Service Bulletin - December 2023

SAF Tire Pilot Plus™ (TPP) Inflation System

Tire Pilot Plus Recall Reactivation/ Upgrade

Electronic Controlled Module (ECM)
controlled systems only

Figure 1

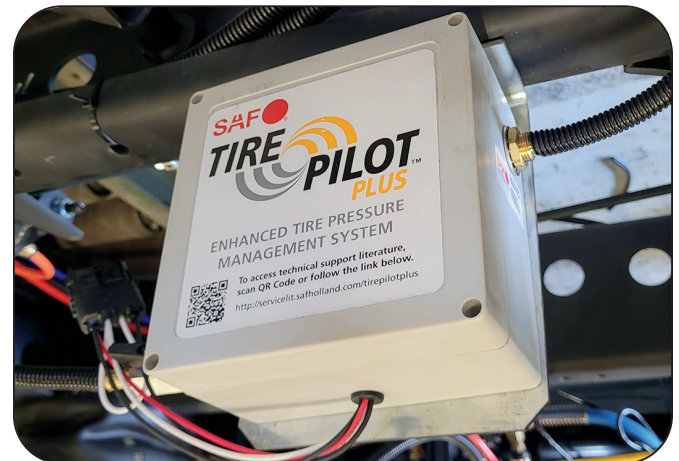
2. **Figure 1** illustrates the electronic regulator. Location is on the front cross-member for a sliding suspension.
 - a. This recall does not include TPP systems with the mechanical regulator installed (**Figure 2**).

- b. Some trailers may have the electronic regulator already removed. If the regulator is not installed the TPP system is not part of the recall. A replacement kit will need to be purchased. See replacement kit selection on page 2.
